Access Compliance Report

Public Rights-of-Way

Intersection ID: 4066	Main Street: W MALLARD CREEK CHURCH RD	Cross Street: DAVID TAYLOR DR	Location: N
ADA ID: 03AA31D67AF5	Ramp Type: PerpDiag	Initial Pass/Fail: Fail	Overall Compliance: No
			Severity Score: 8.75

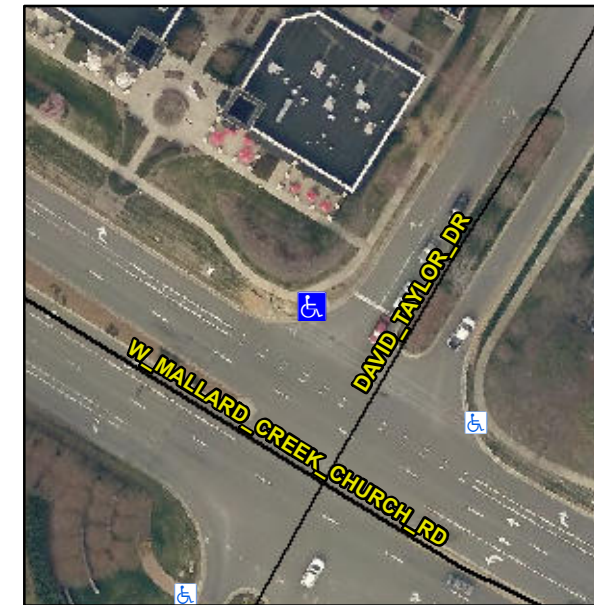
Not Found, R304.5.1

Compliance	Description	Data	Compliance	Description	Data
N/A	Ramp Length (in)	96.0	Yes	Ramp Slope (%)	6.0
No	Ramp Width (in)	40.0	Yes	Ramp XSlope (%)	1.6
N/A	Flare Type LT	N/A	N/A	Flare Type RT	N/A
N/A	Flare Slope LT (%)	N/A	N/A	Flare Slope RT (%)	N/A
N/A	Flare Traversable LT?	N/A	N/A	Flare Traversable RT?	N/A
N/A	Landing Length (in)	N/A	N/A	DWS Provided?	N/A
N/A	Landing Width (in)	N/A	N/A	DWS Contrast?	N/A
N/A	Landing Slope (%)	N/A	N/A	DWS Length (in)	N/A
N/A	Landing X Slope (%)	N/A	N/A	DWS Full Width?	N/A
N/A	Landing Curb? (Y/N)	N/A	N/A	DWS Offset (in)	N/A
N/A	Shared Landing?	N/A			
N/A	Gutter Ponding?	N/A	N/A	Gutter Slope (%)	N/A
N/A	Gutter Lip Ht (in)	N/A	N/A	Gutter X Slope (%)	N/A
N/A	Painted X Walk1?	No	N/A	Painted X Walk2?	No
	X Walk 1 Direction	To SW		X Walk 2 Direction	To SE
N/A	X Walk 1 Width (in)	N/A	N/A	X Walk 2 Width (in)	N/A
	X Walk 1 Slope (%)	3.2		X Walk 2 Slope (%)	1.6
	X Walk 1 X Slope (%)	1.4		X Walk 2 X Slope (%)	2.7

Remove & Replace Curb Ramp With Two New Directional Ramps or Equivalent.
